SUPPLEMENT NO. 1

PHILIP R SMITH ELEMENTARY SCHOOL
GILBANE JOB NO. J07896.000
STATE PROJECT NO. 132-0089N

PRS-SI-0007

Owner Room Names and Signage

A5.7

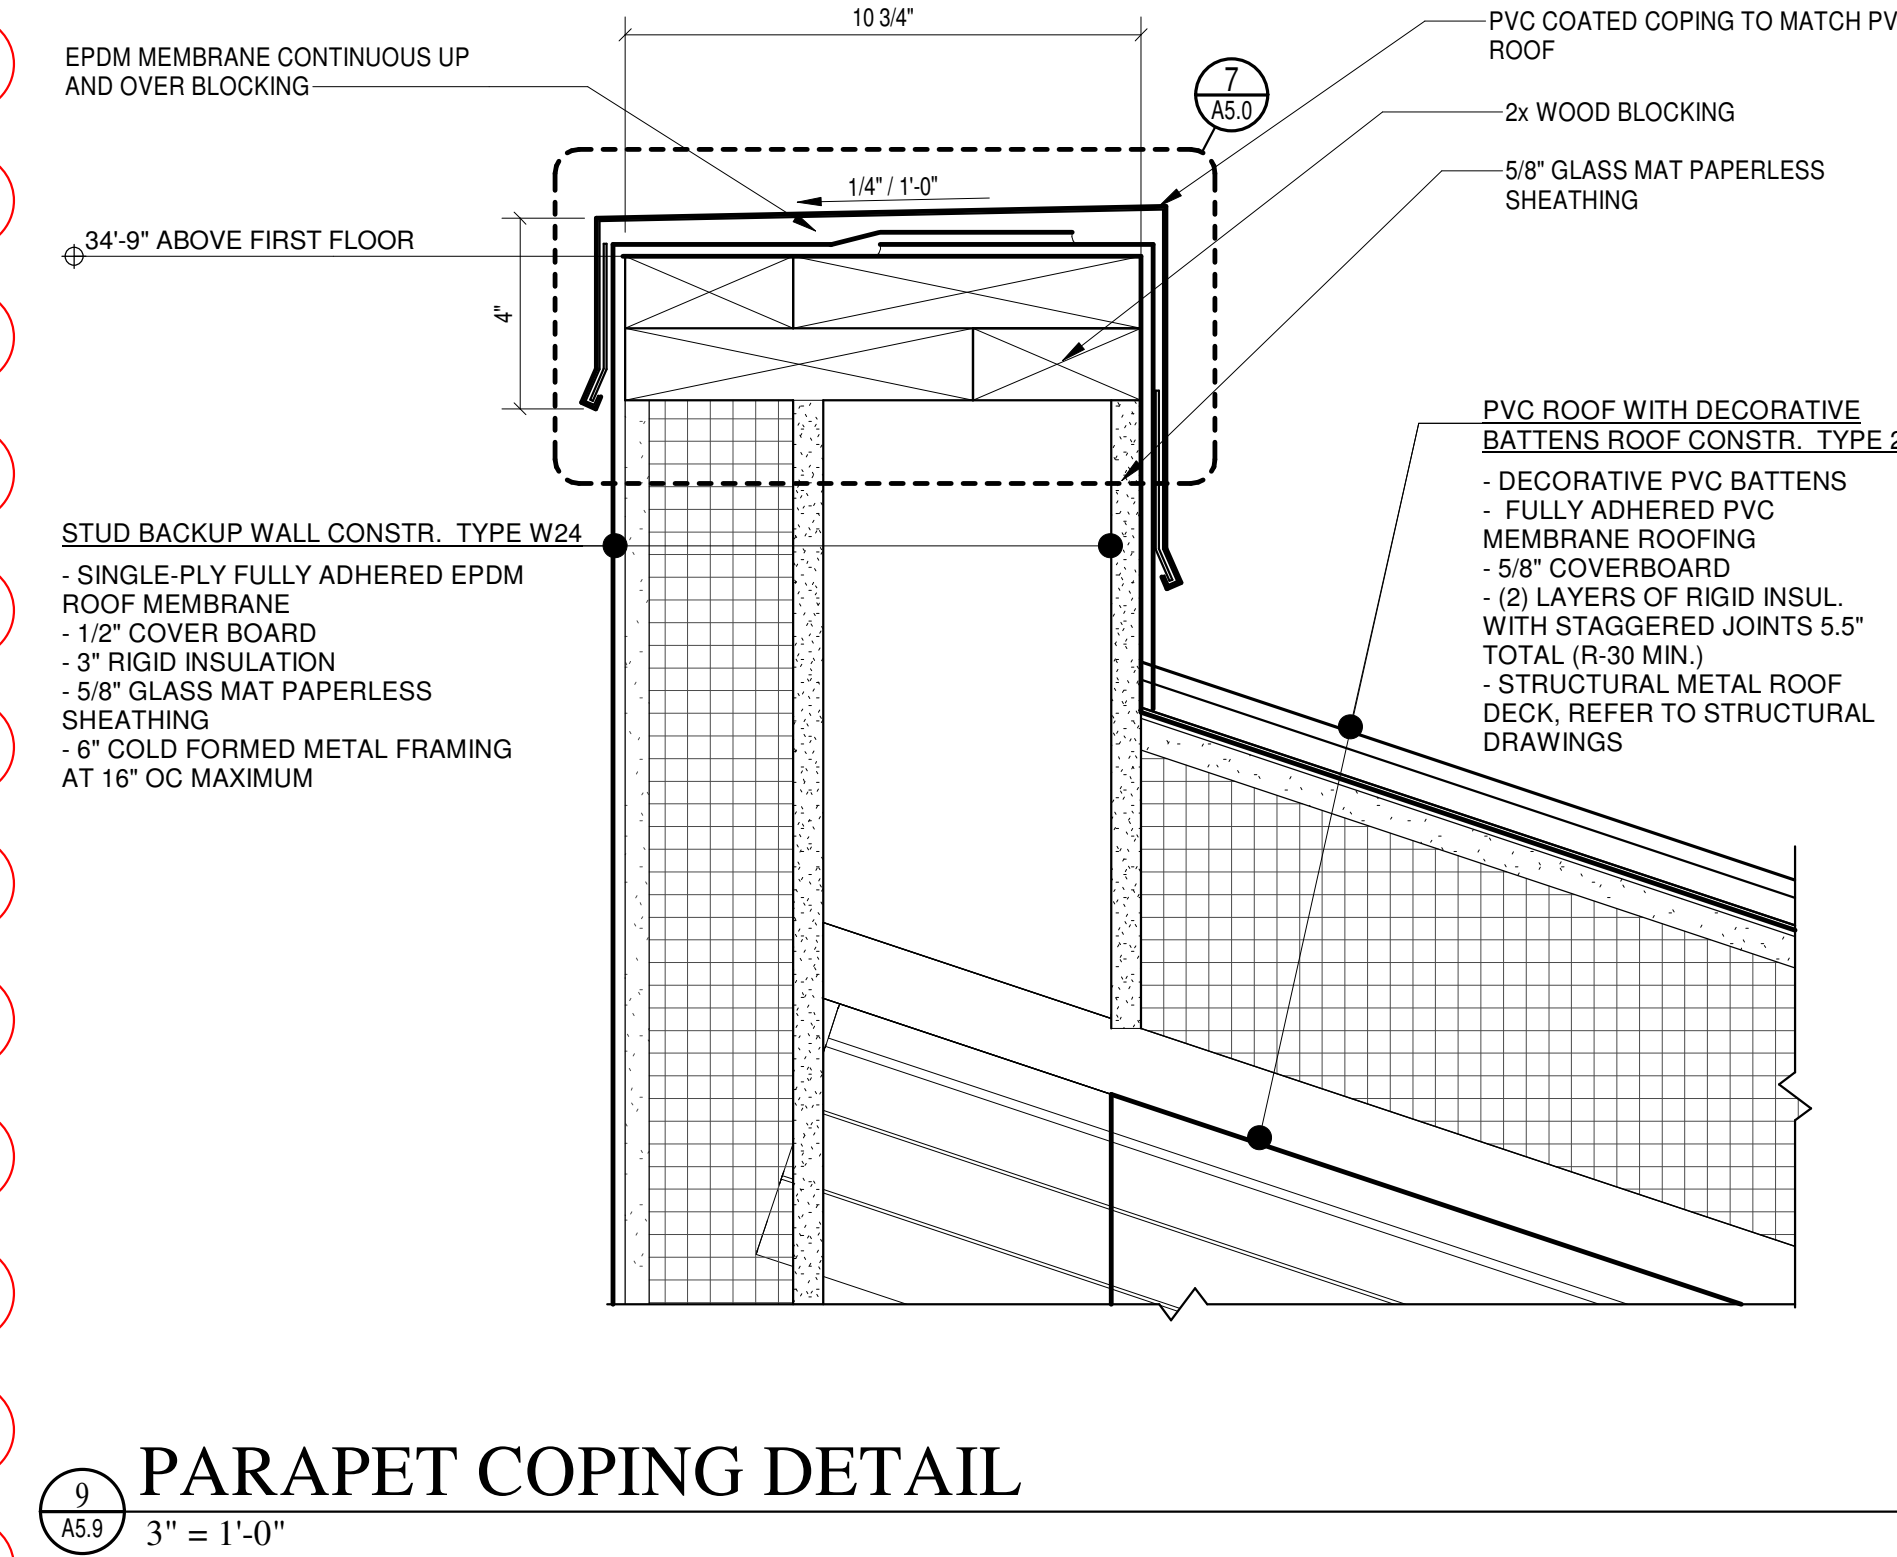
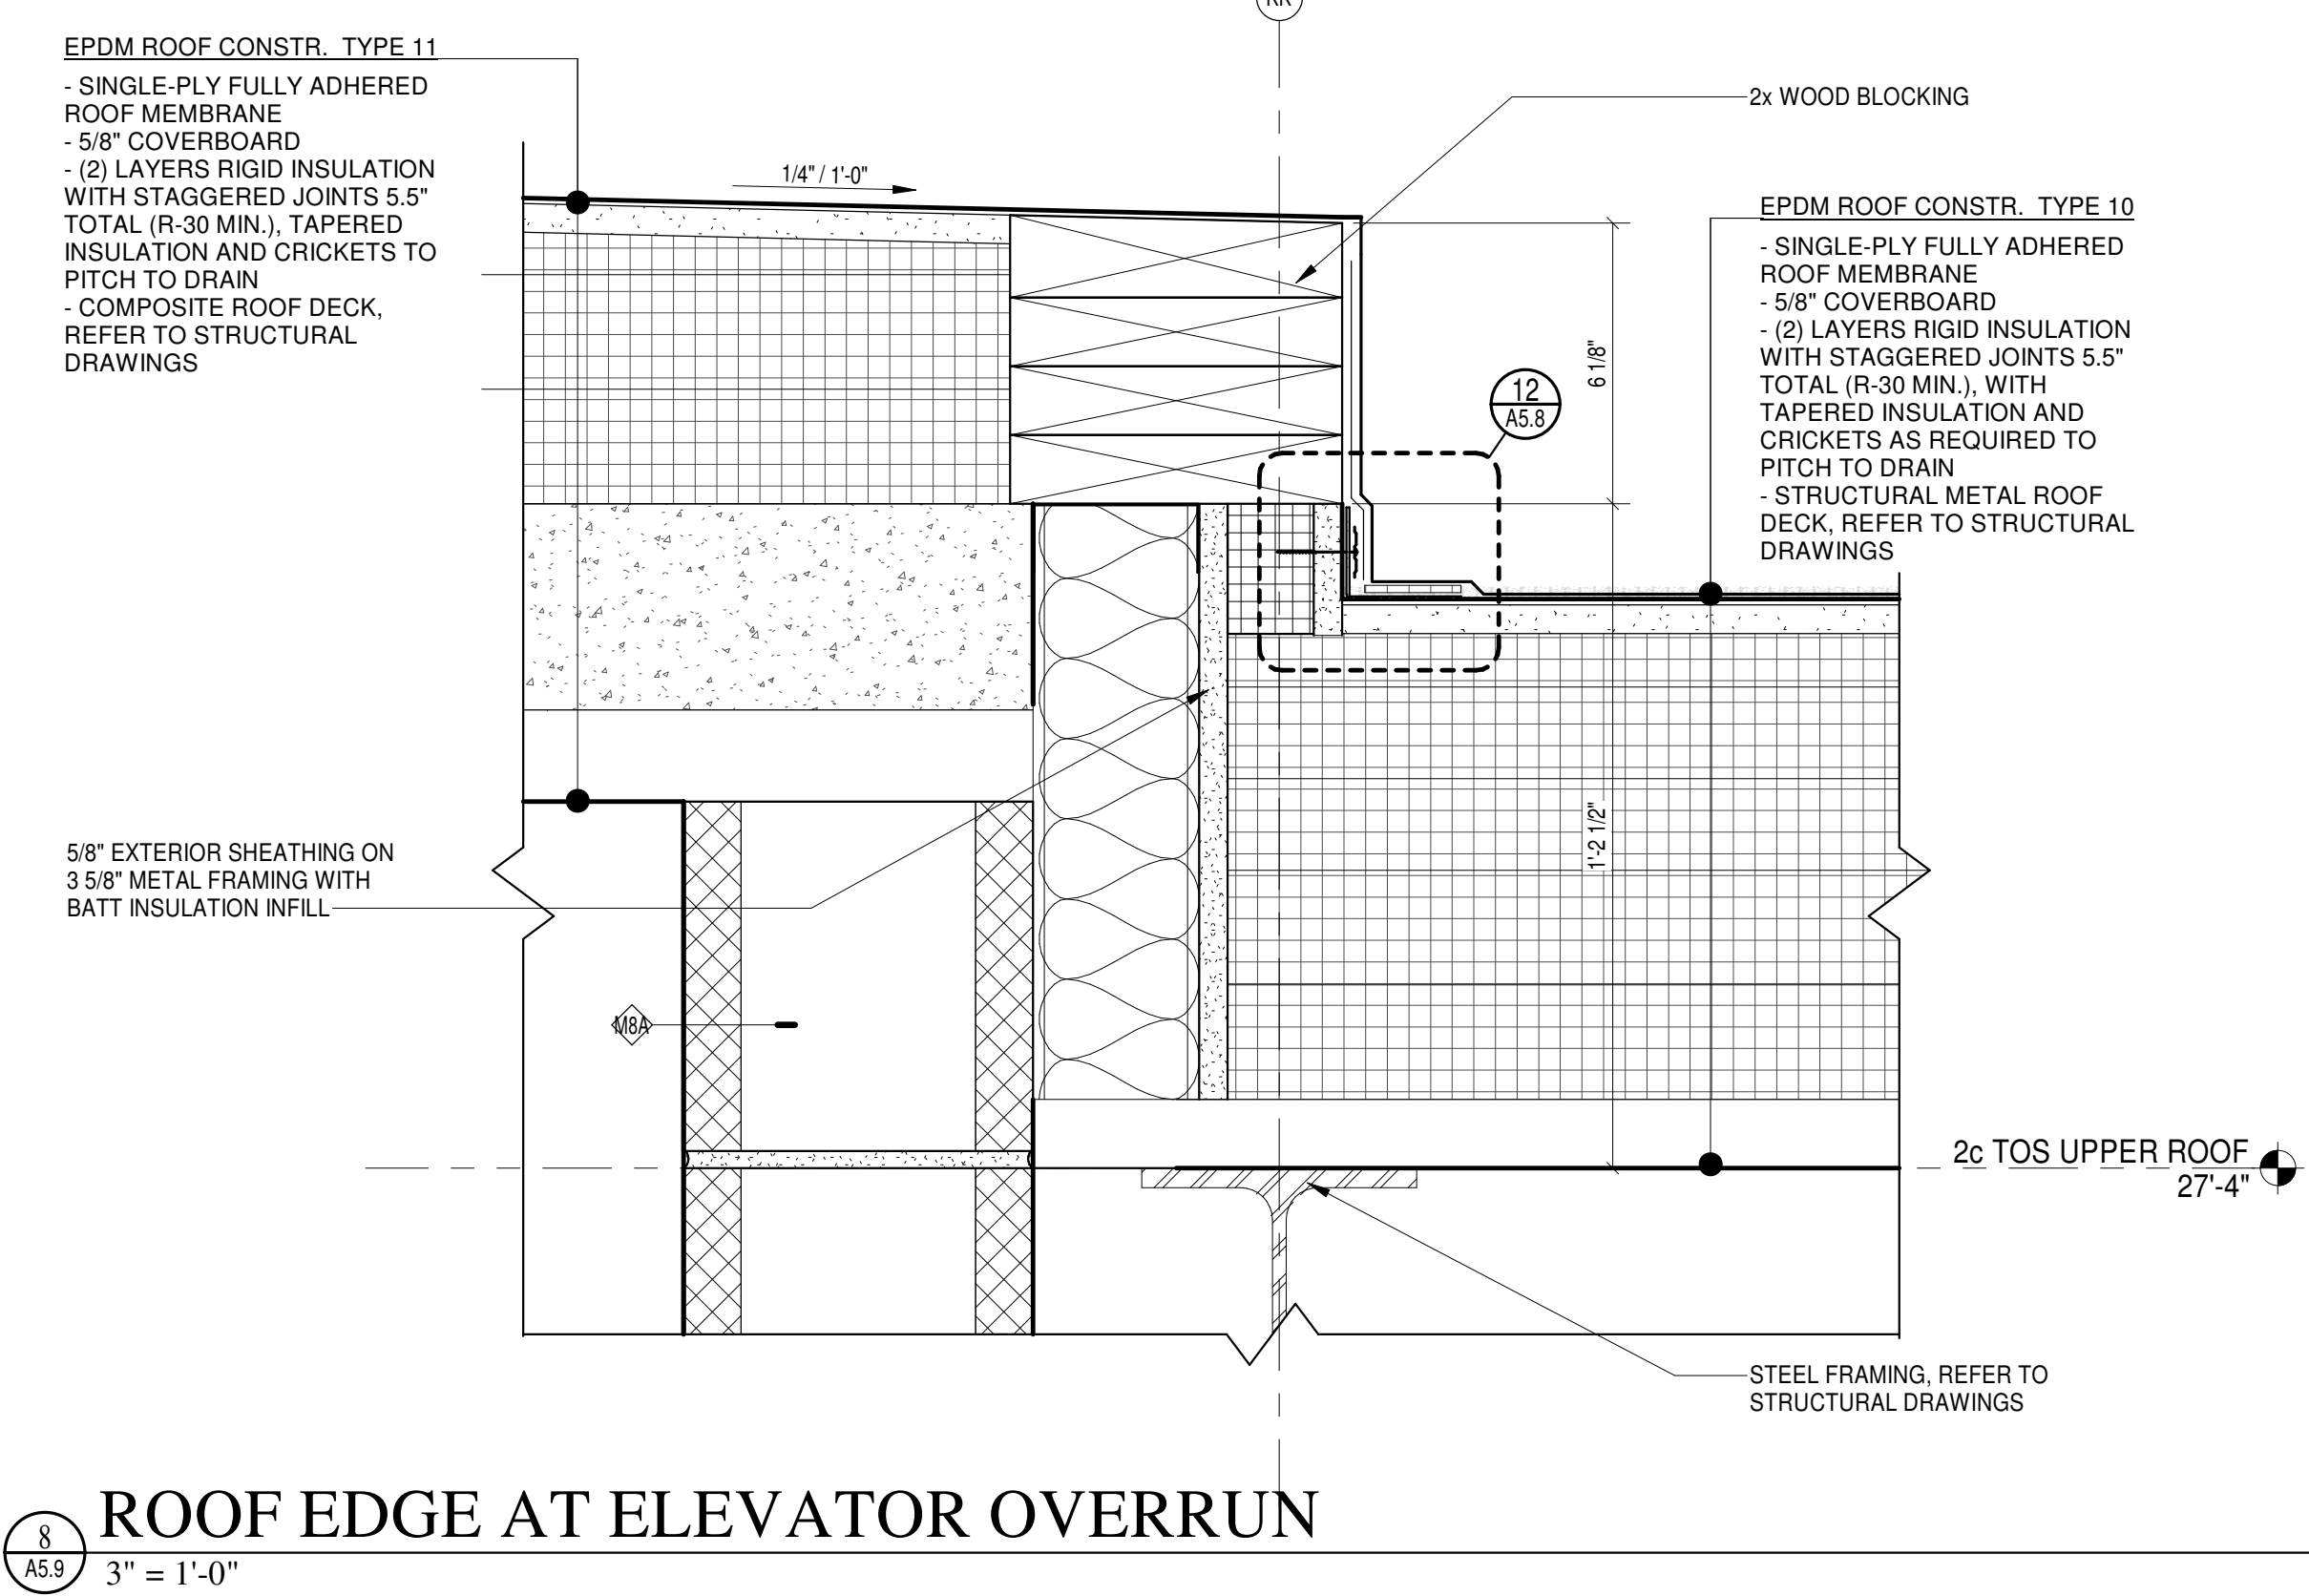
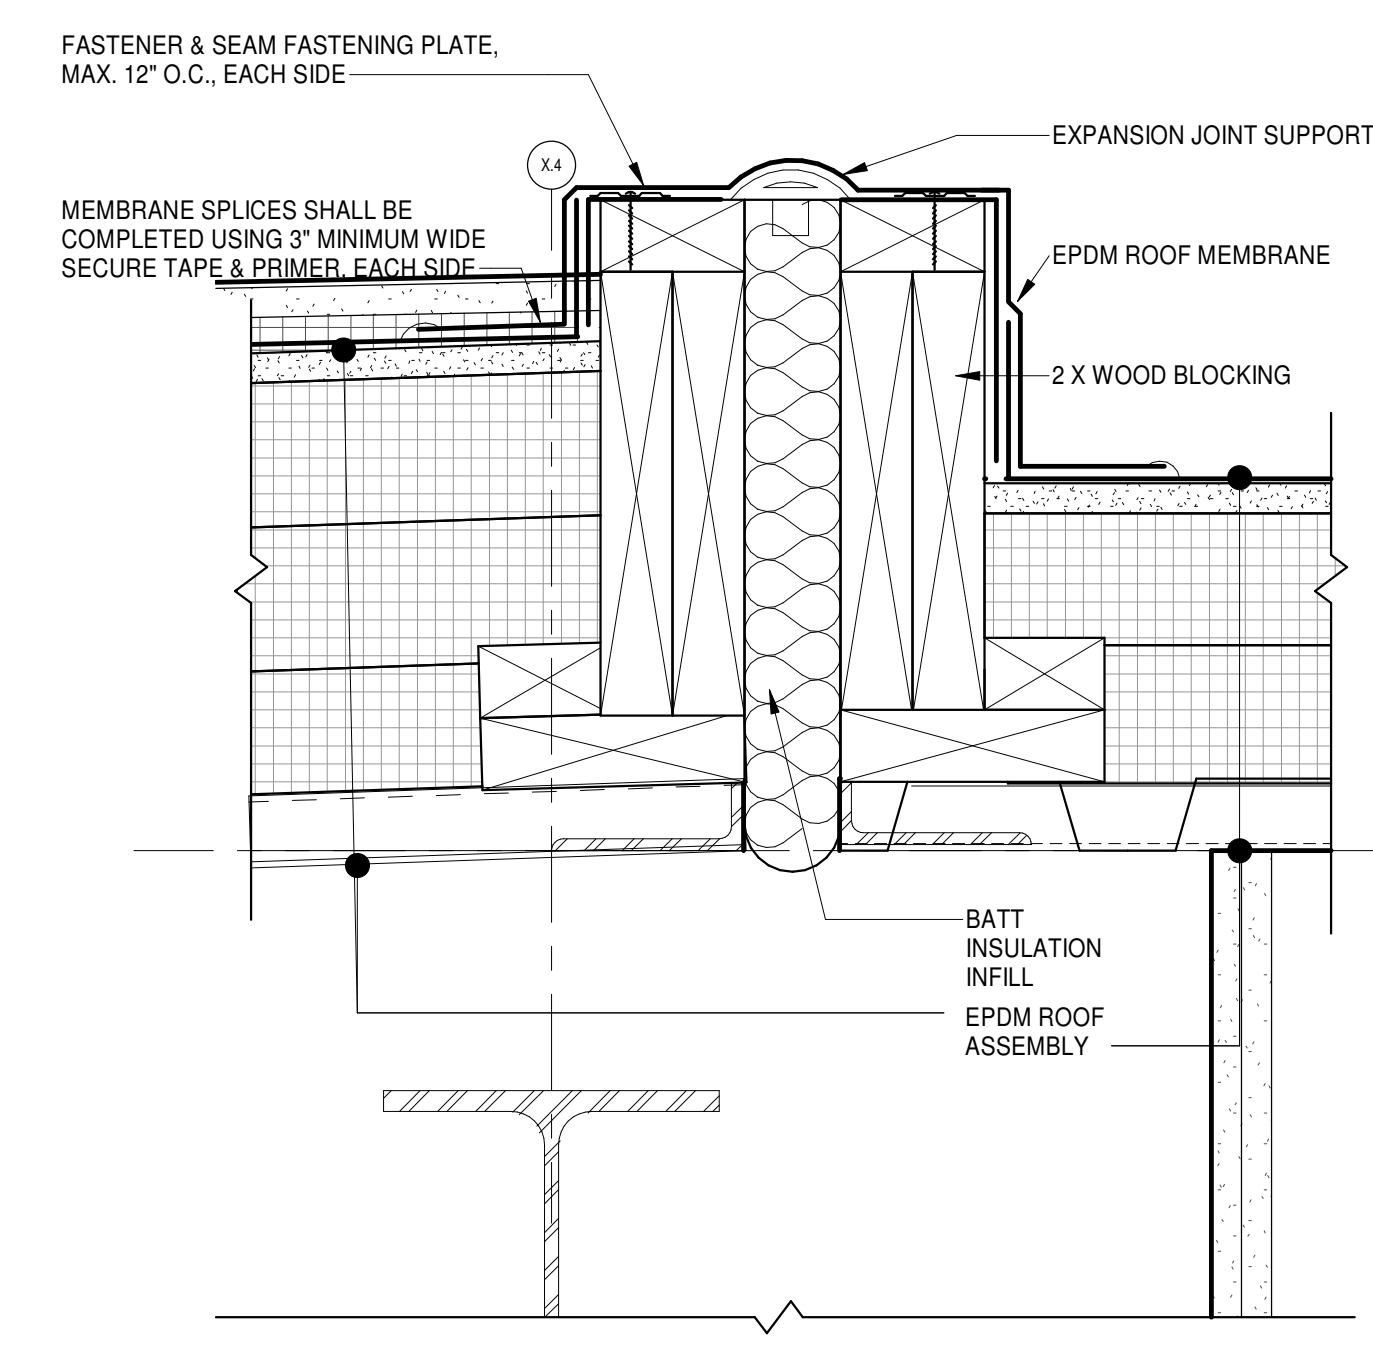
DRAWING A5.7 - EXTERIOR DETAILS: **REMOVE** drawing as Issued for Bids and **REPLACE** with drawing attached to this Addendum with the following revisions:
